TALBOT MILLS DAM REMOVAL / CONCORD RIVER ECOLOGICAL RESTORATION PROJECT

HISTORIC DISTRICTS COMMISSION CERTIFICATE APPLICATION

Re: Talbot Mills Dam Removal / Concord River Restoration Project
Application for Historic Districts Commission Review/Certificate

6. Response to BHDC Comments on MEPA EENF

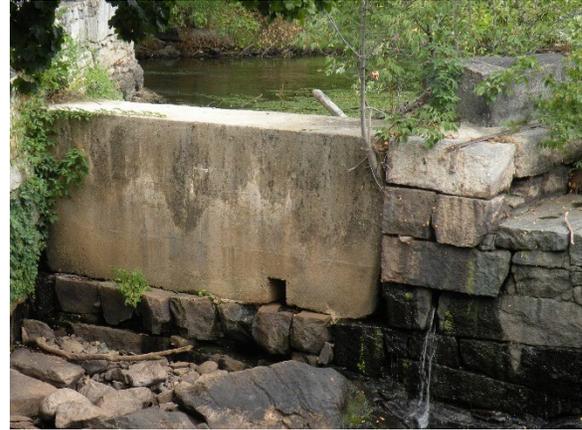
- *2021 Merrimack River Watershed Comprehensive Plan for Diadromous Fishes (2021 Fish Plan). The plan states that “NOAA Fisheries Restoration Center and MADMF are working closely with the Talbot Dam owner to improve fish passage at the site with dam removal the preferred alternative.” Note that removal is one alternative, it’s not the only option. The plan later calls into question whether fish are even reaching Talbot Mills, stating that “fish passage effectiveness at the [Centennial Dam downstream of Talbot Mills] has not been evaluated, despite [the dam’s] importance as the first barrier in the system,” and observes that multiple options exist “to provide fish passage, ranging from installing a fish ladder to complete removal of the dam.”*

5. Response: See Response 2 above regarding planned improvements at Centennial Island Dam and Response 3 regarding the evaluation and dismissal of the fish ladder alternative at Talbot Mills Dam.

Interestingly, the story map portion of the MRWC Website includes several figures illustrating the extent of the Merrimack River watershed. In those figures . . . the MRWC describes the green portions of the rivers as “habitat available to migratory fish today.” Note that the vast majority of this apparently available habitat is, in fact, upstream of the Essex Dam fishway in Lawrence. So, in the MRWC’s own estimation, fishways increase available habitat above an otherwise impassible barrier like the Talbot Mills Dam.
